**ADDENDUM
NO. 2**

Richland Bean Blossom Schools Roofing & Mechanical Renovations
Various Schools Locations
Ellettsville, IN 47429

PROJECT: Richland Bean Blossom – Roofing & HVAC
Junior High School

DATE OF ADDENDUM: February 10, 2026

ROOF DETAILS

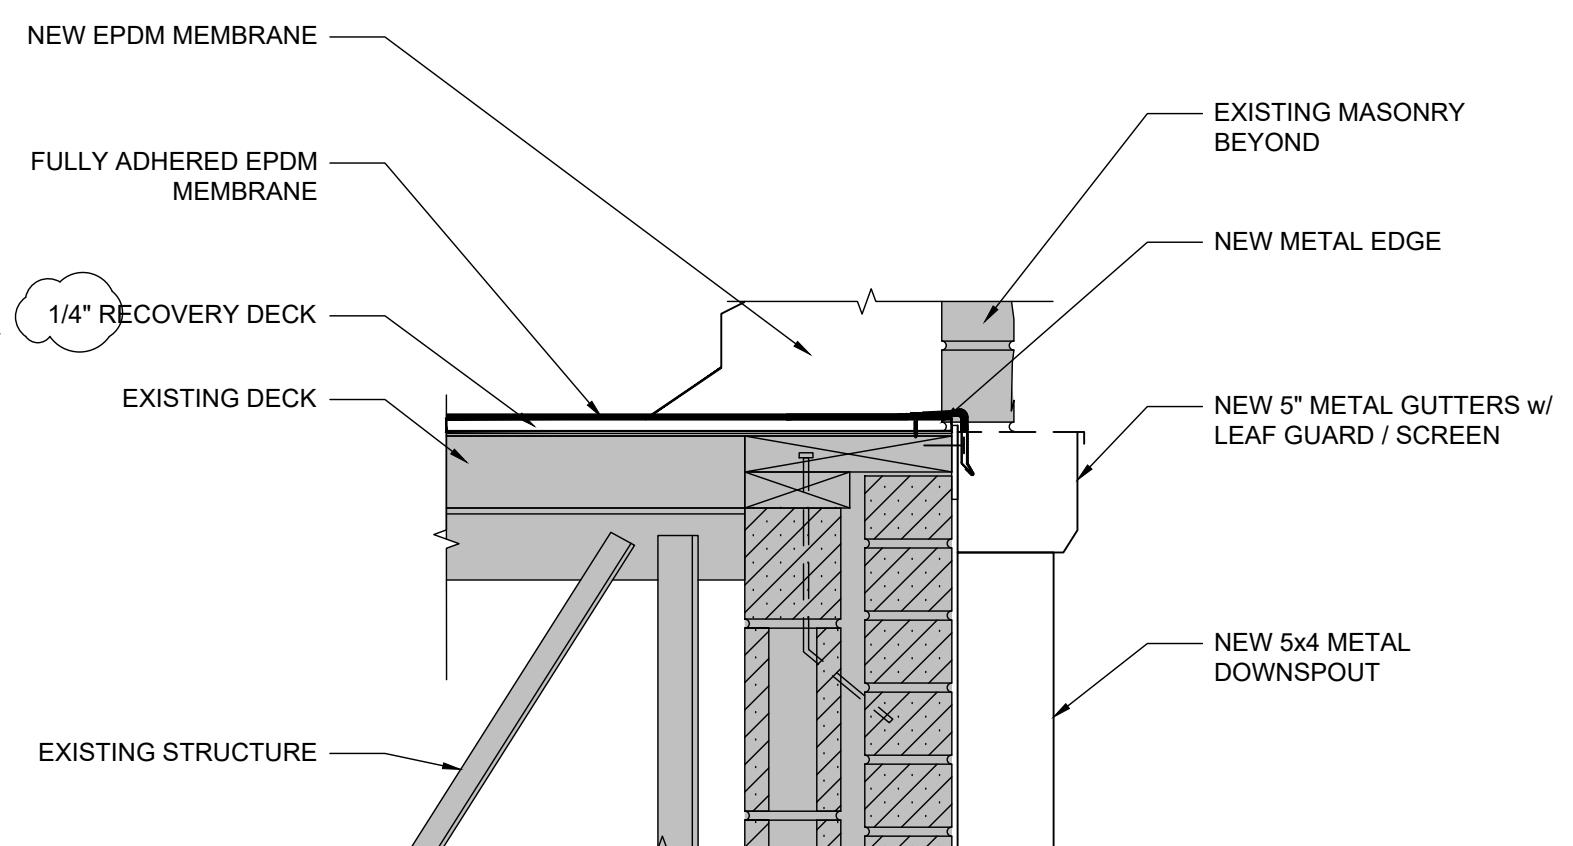
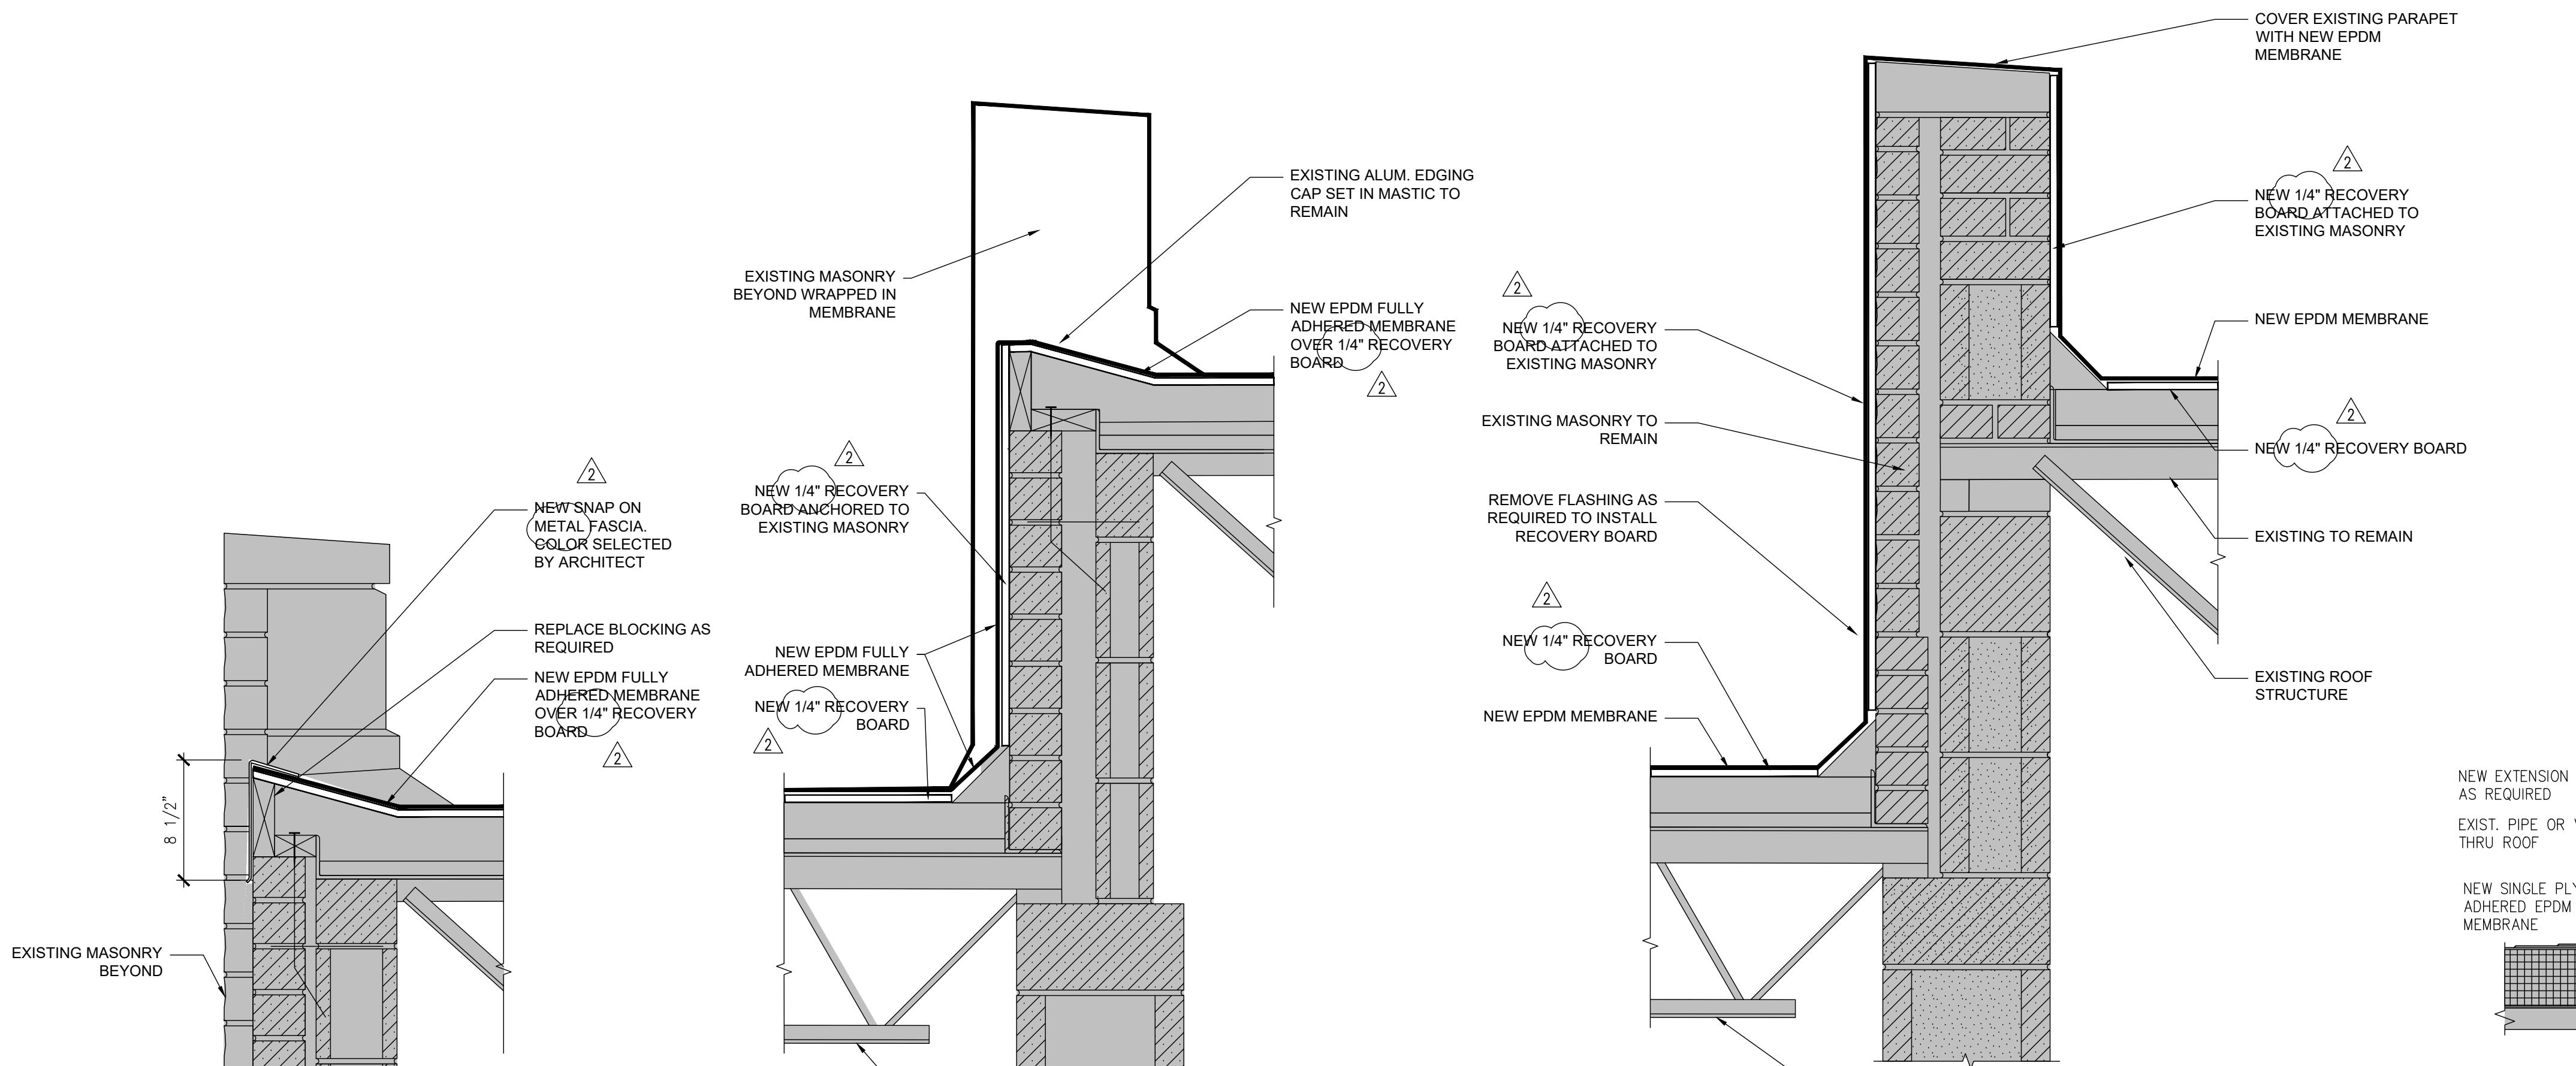
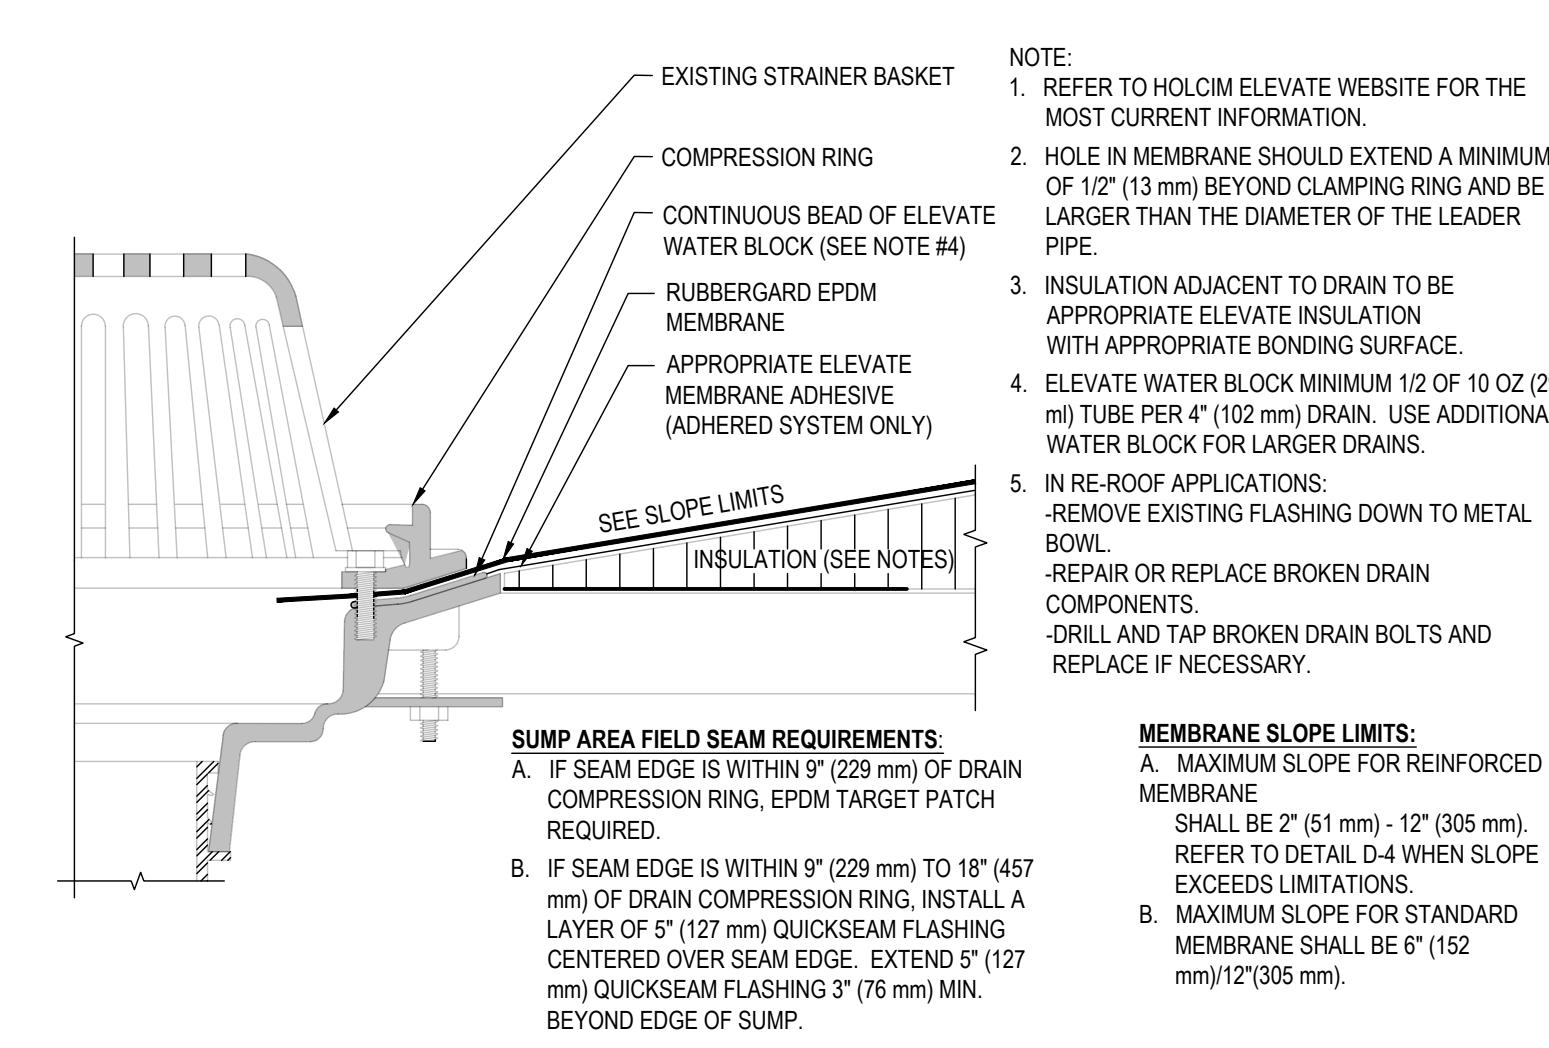
Change: All the recovery board shall be 1/4 inch thick.
